# ISSUED FOR DR-3 RESPONSE

(DP2025-02420)

## "PARKLINE" PHASE 1 - MULTI-FAMILY BLDG

TBD RICHMOND RISE S.W.

## Bylaw Plan

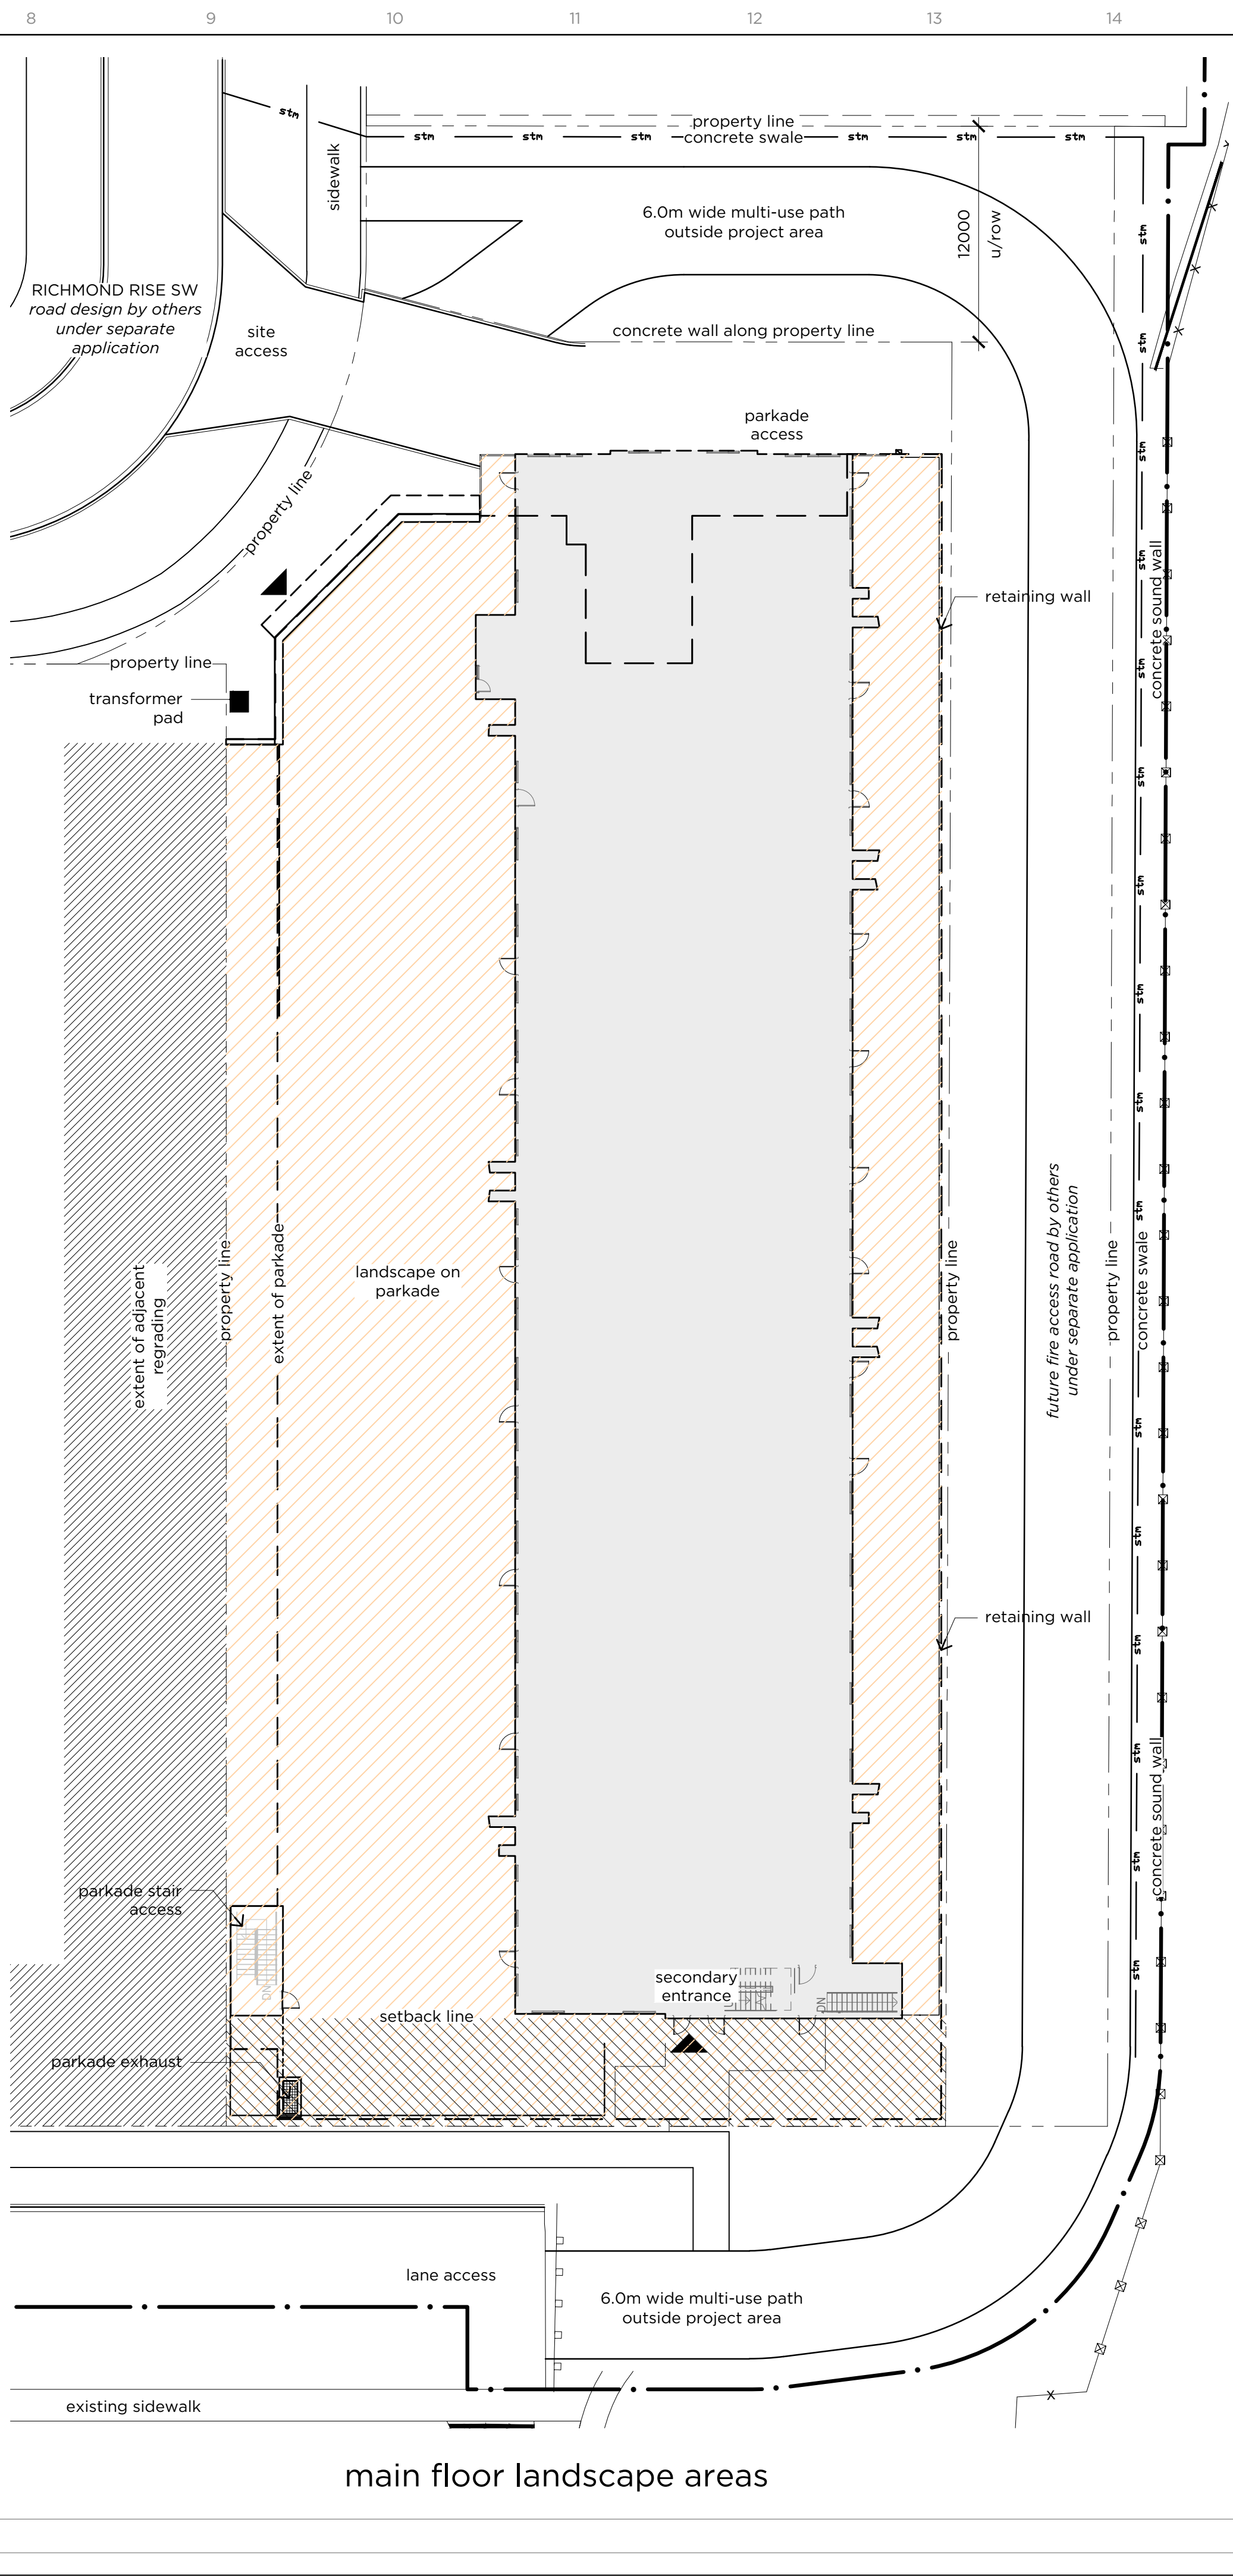
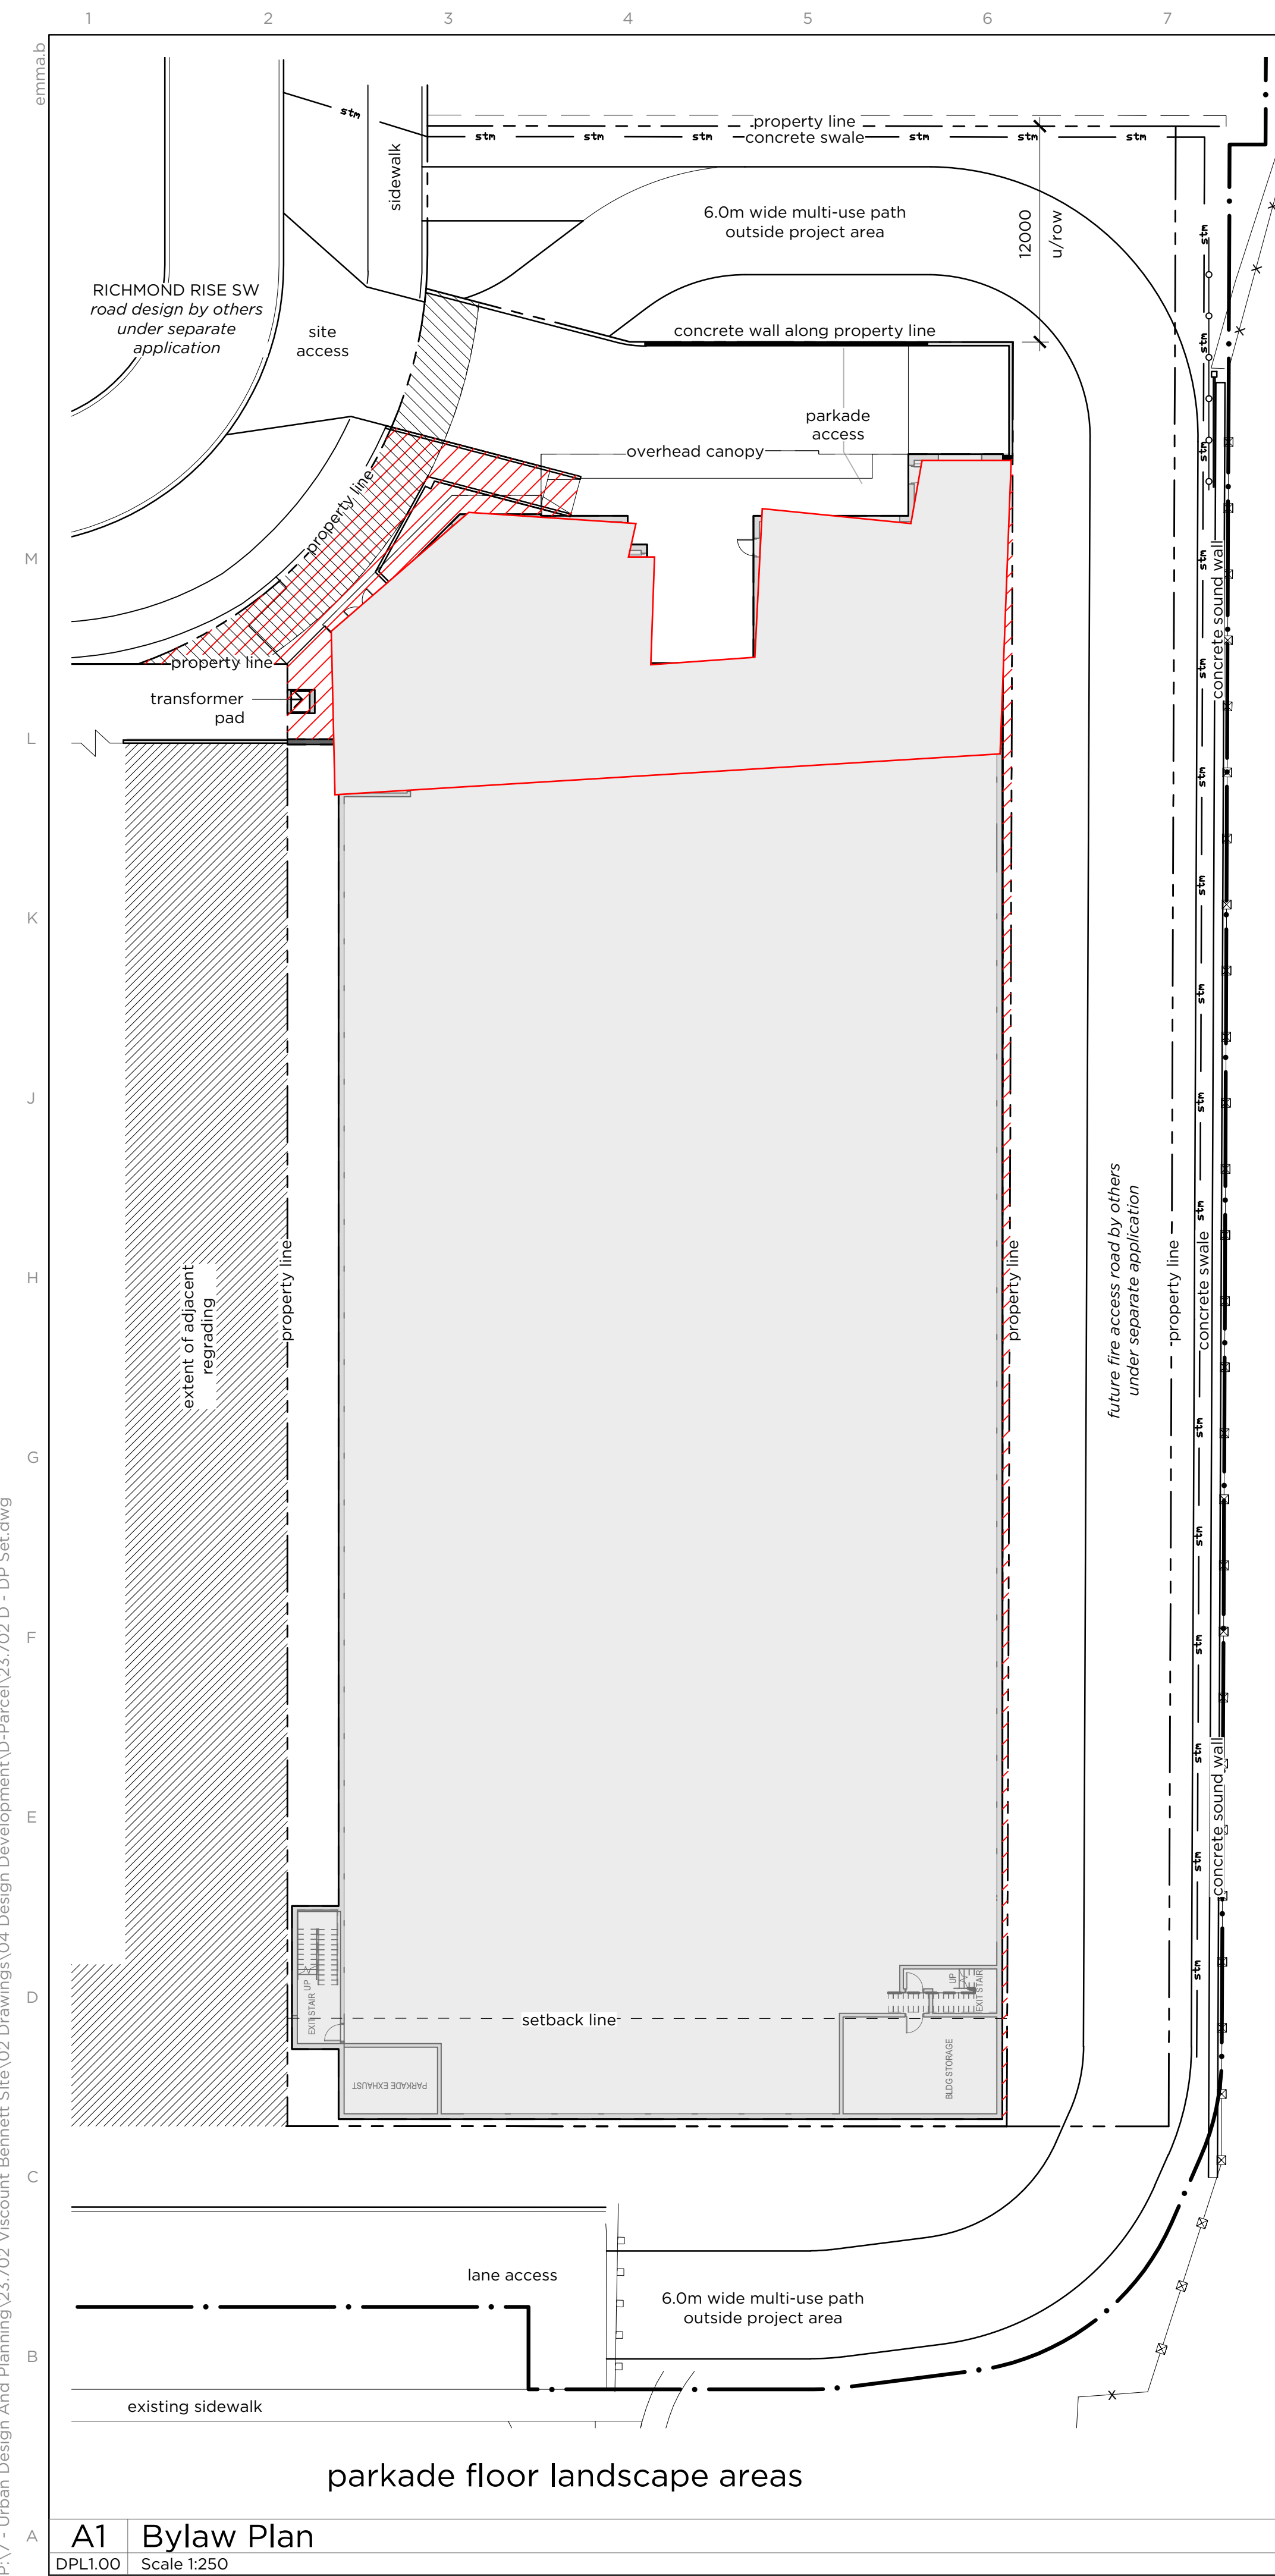
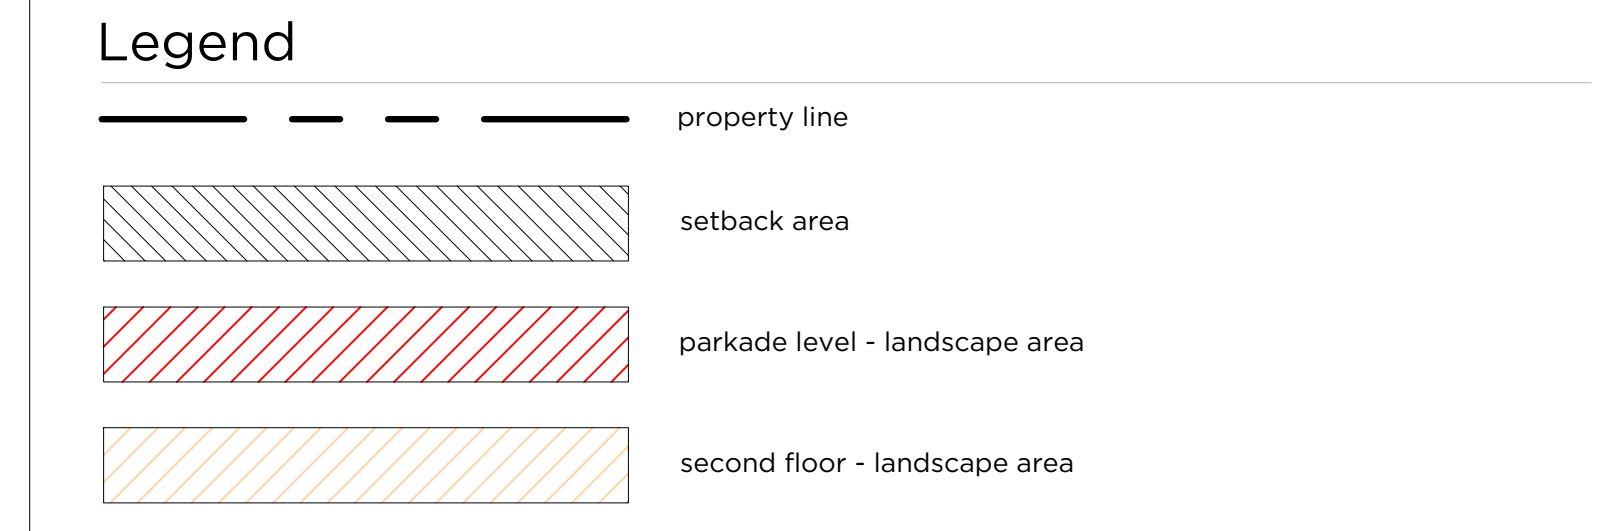
- ### REVISIONS
- 1) bylaw plant count calculations updated to match DPL1.10 and DPL1.20
  - 2) 2.7m<sup>2</sup> removed from hardscape calculation, refer to L1.10
